2014 - 2017 Corvette: GM TechLink: Fuel Line Pulsation Sound

Fuel Line Pulsation Sound

GM TechLink

FIG. 9

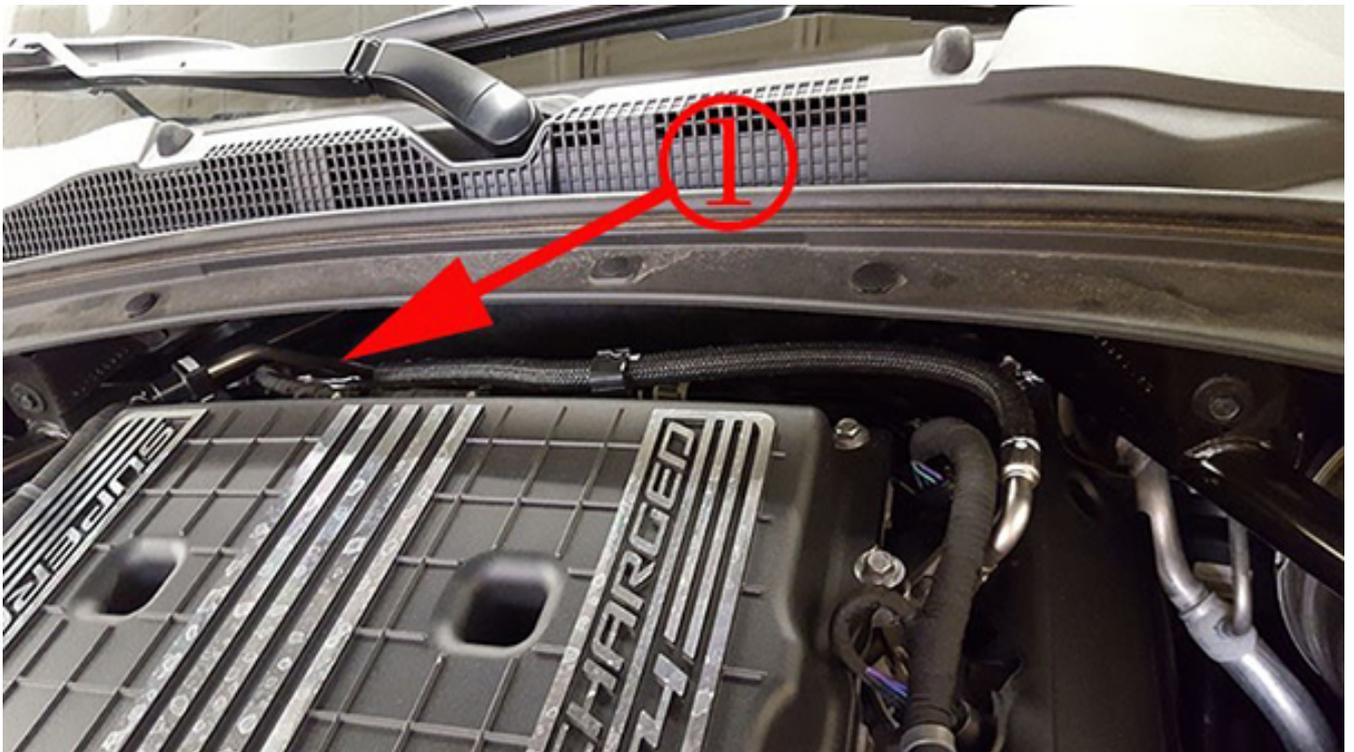
Listen to the fuel line connection at the left side of the engine. The fuel feed line between the high pressure fuel pump and chassis fuel line may be allowing high pressure pulsation back to the low side of the fuel system. If the sound is heard, the line will need to be replaced. On some trucks and SUVs, a vibration also may be observed in the fuel line at the fuel tank.

There are two different types of fuel lines that contain a check valve. The lines vary by model. Only one line should be used on Corvette, truck and SUV models. (Fig. 9) The line connects the chassis fuel line to the high pressure fuel pump. (Fig. 10)
